CITY OF LAKEPORT

ADDENDUM NO. 2
2024 WATER & SEWER MAIN REPLACEMENT PROJECT
Bid No. 23-05

Issue Date: April 23, 2024

DETAIL 'D'
INSTALLING PIPE IN WET CONDITIONS

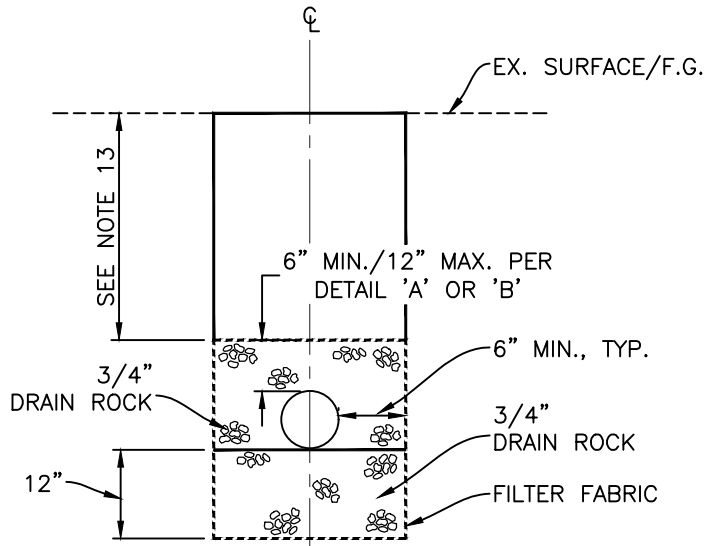
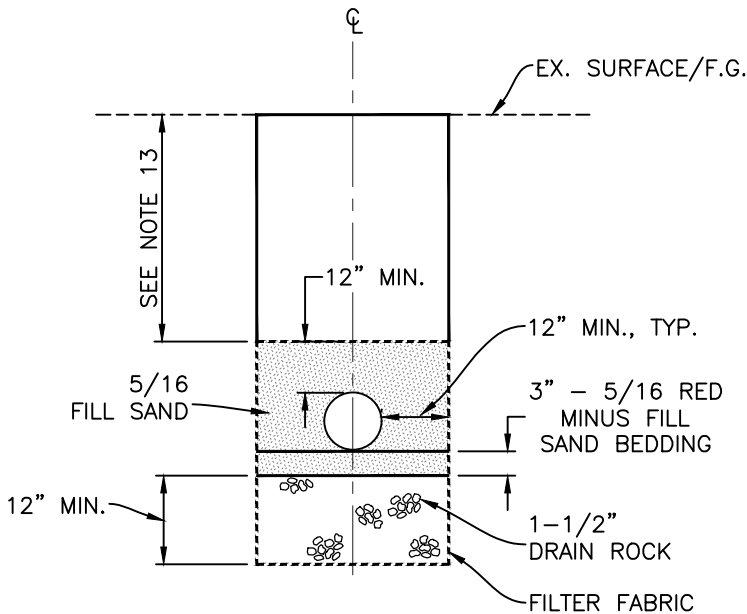
12. Bid item # 84 – Trench Over Excavation; Since the item is based on (LF) please clarify the depth of over excavation below the pipeline design trench invert. Clarify if the filter fabric is place at the bottom of the trench and then the drain rock is place?

- A. See revised Standard Detail 222 (5 pages)
13. Lakeport Blvd/Bevins St notes to T-Cut paving for all trenches from sta 700+40 - 708+40. AT station 704+61 the notes changes not to t-cut the paving. Please clarify the stationing for T-cut and no T-cut.

- A) TRENCH DEPTH VARIES – EXCAVATE 12” BELOW PIPE. ENGINEER MAY WANT LESS OR MORE DEPENDING ON CONDITIONS.
- B) INSTALL FILTER FABRIC @ BOTTOM OF EXCAVATION.
- C) 3/4” DRAIN ROCK 6’ MIN., 12” MAX. ABOVE THE TOP OF PIPE.
- D) NO COMPACTION REQUIRED ON 3/4” DRAIN ROCK.

- A) INSTALL FILTER FABRIC @ BOTTOM OF TRENCH.
- B) PLACE 1-1/2” DRAIN ROCK.
- C) PLACE FILTER FABRIC OVER TOP OF DRAIN ROCK.
- D) PLACE & COMPACT 3” LAYER OF 5/16” FILL SAND BEDDING.
- E) PLACE 5/16” FILL SAND OVER PIPE.
